SUBDIVISION COMMITTEE
METROPOLITAN AREA PLANNING COMMISSION

STAFF REPORT
(Final Plat)

CASE NUMBER: S/D 91-55 - HUNTINGTON PLACE 4TH (5TH) ADDITION

VICINITY MAP:

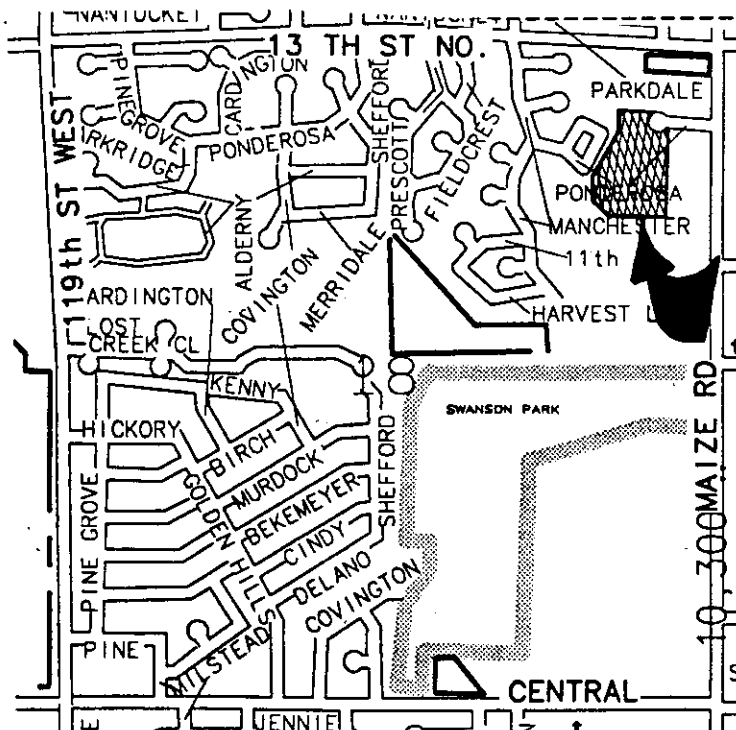
- A. As indicated by the plat, access to this site is from Maize Road, by way of Ponderosa Circle. This street, however, was dedicated by the Huntington Place Commercial Addition immediately to the east of this plat. The Commercial Addition also provided guarantees for this street, the extension of water, etc. Engineering needs to indicate if sufficient guarantees are already in place for street paving, including sidewalks, sanitary sewer, water, and drainage improvements or if this plat needs to submit any additional guarantees.

- C. At the time that the Huntington Place Commercial Addition was platted a 20 foot wide emergency access easement was platted along the south end of that plat to provide an additional entrance to this site. To assure that this entrance is not blocked on this site, that easement should be sufficiently extended into this addition at the corresponding location at the southeast corner of the plat.

The Fire Department should be prepared to indicate any requirements it may have concerning this easement; including not only any gateway requirements but also the paving of a surface in this easement, particularly since the Commercial Addition has not yet been developed.
- D. City Engineering should be prepared to indicate any easement requirements that it may have for sanitary sewer. In particular it should be noted that the 10 foot easement along this plat's east line is separated from a 10 foot easement on the adjacent plat by a 5 foot wall easement which runs the length of this plat's east line (this wall easement crosses the emergency access easement).
- E. On the final plat tracing a 35 foot building setback shall be indicated from Ponderosa Circle. This is in addition to any other setback requirements established by the CUP.

- G. Two drainage easements are indicated on the title binder as effecting this site. The applicant shall indicate the location of these easements. No indication is made in the surveyor's text that any such easements are being vacated and no drainage easement is shown on this final plat. Engineering should be prepared to comment if any easements are being proposed for vacation. Copies of the instruments establishing these easements shall be submitted for the plat file.
